Serial Number: 09/752,026  
Amdt. Dated October 21, 2004  
Reply to Office Action of July 22, 2004

#### REMARKS/ARGUMENTS

FIG. 2

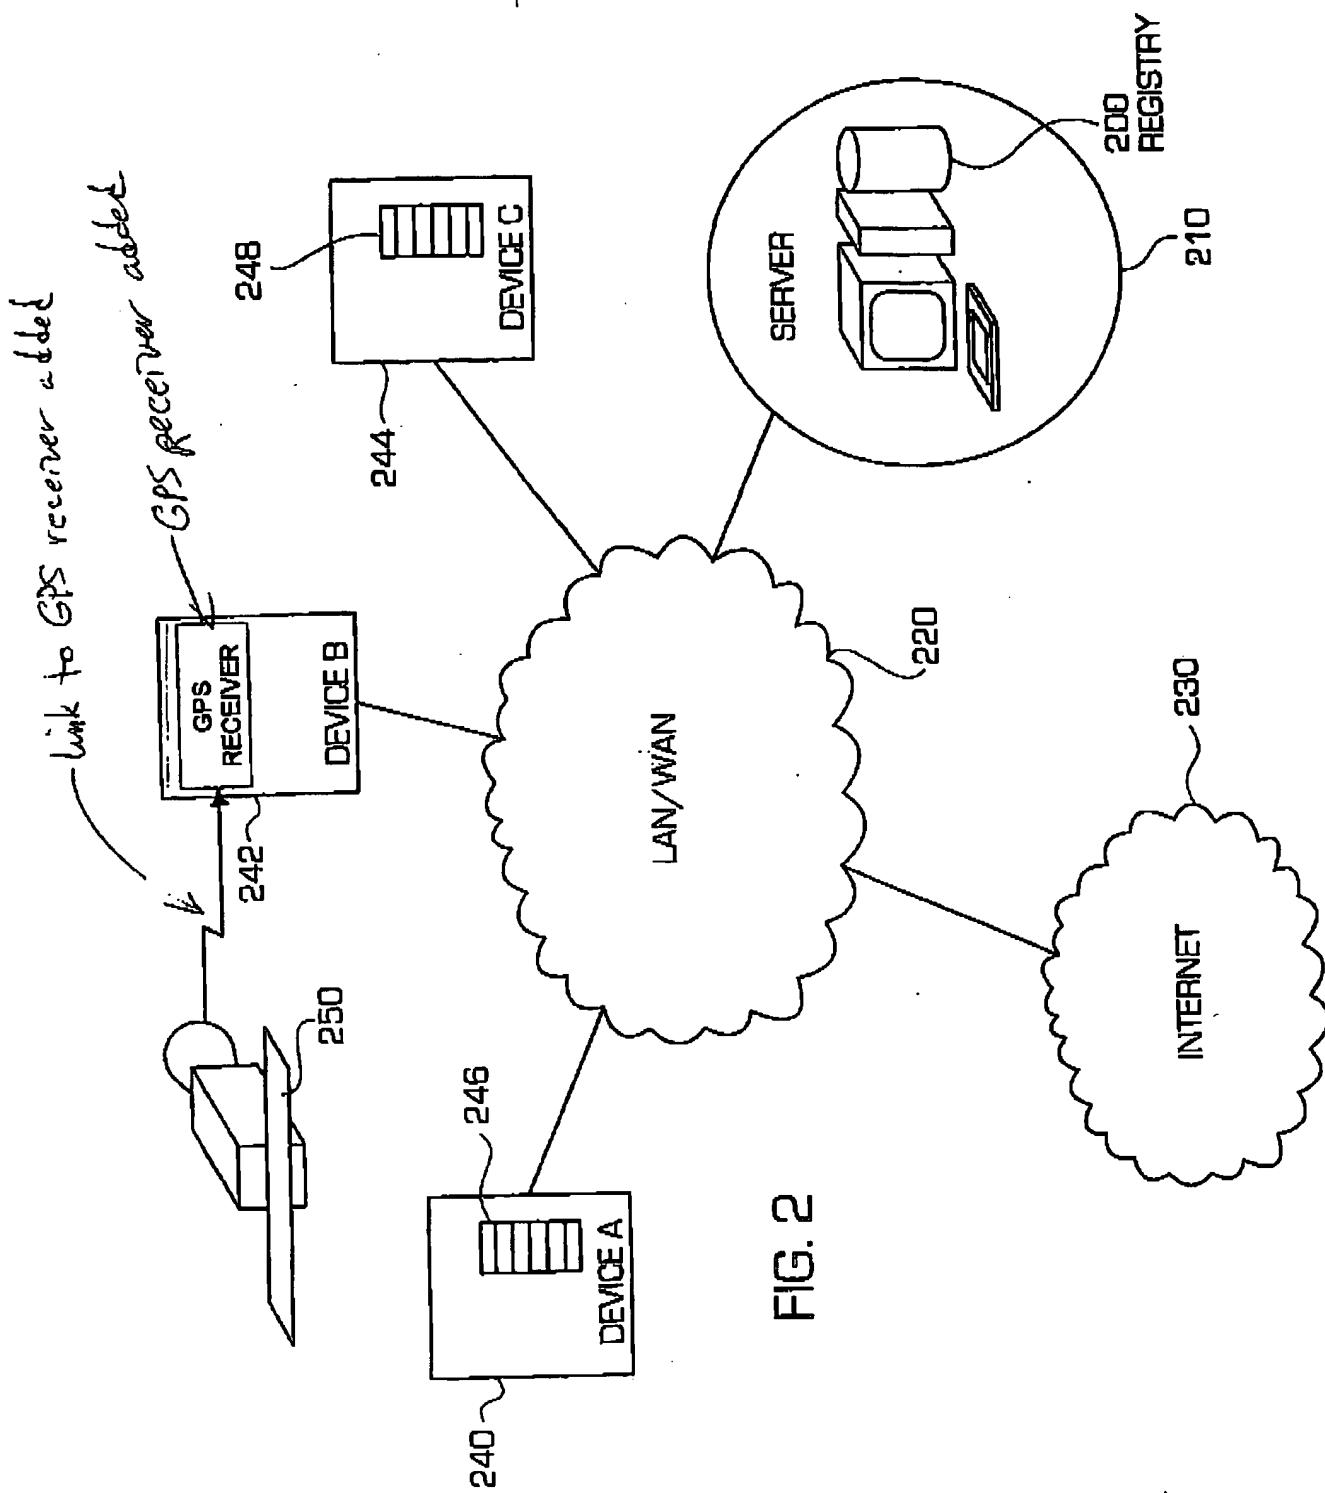
#### *Objection to the drawings because of partial views in figures 2 and 3*

Modified figures 2 and 3 are provided showing element 250 (figure 2) and element 337 (figure 3) communicating positional information to a GPS receiver within Device B (figure 2) and Internet Appliance 320 (figure 3). This is not considered to be new matter to this application, as the specification at, page 10, lines 11-13 states:

In the amended figures 2 and 3, a connection between the GPS satellite and a GPS receiver within a device of the system has been shown.
